CITY OF FORT LAUDERDALE

## CASE COMMENT REPORT

CASE NO. UDP-S25015

<b>CASE</b>	UDP-S25015
<b>PROJECT NAME</b>	Top Shottas Gun Range
<b>APPLICATION TYPE</b>	Site Plan Level III
<b>APPROVAL LEVEL</b>	Planning and Zoning Board
<b>REQUEST</b>	Conditional Use for an Indoor Firearms Range and Associated Parking Reduction
<b>APPLICANT</b>	Gala Home, LLC.
<b>AGENT</b>	Eugene Pierre, Owner Ryan Abrams, Abrams Law Firm, P.A.
<b>PROPERTY ADDRESS</b>	5233 N. Powerline Road
<b>ABBREVIATED LEGAL DESCRIPTION</b>	LJB Plat 122-10 B, Parcel A
<b>ZONING DISTRICT</b>	Heavy Commercial/Light Industrial Business District (B-3)
<b>LAND USE</b>	Commercial
<b>COMMISSION DISTRICT</b>	1 – John Herbst
<b>NEIGHBORHOOD ASSOCIATION</b>	N/A
<b>SUBMITTED</b>	April 24, 2025
<b>COMPLETENESS ISSUED</b>	June 11, 2025
<b>EXPIRATION</b>	December 8, 2025 (180 Days)
<b>WAIVER</b>	N/A
<b>CASE PLANNER</b>	Nancy Garcia, Urban Planner II

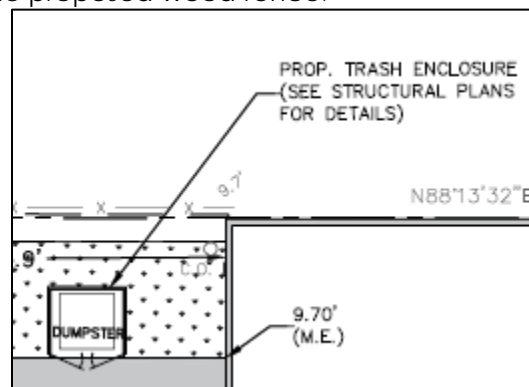
9. Signage was not reviewed as part of this DRC submittal. Any proposed signage (including but not limited to wall or ground signage) shall be reviewed and approved under a separate building (sign) permit.
10. If the proposed improvements are not associated with a City project, remove the "City of Fort Lauderdale Public Works Department" title block from the civil plan set. A screenshot of the referenced pages is provided below. Additionally, "Lauderdale" is misspelled on the cover sheet of this plan set.
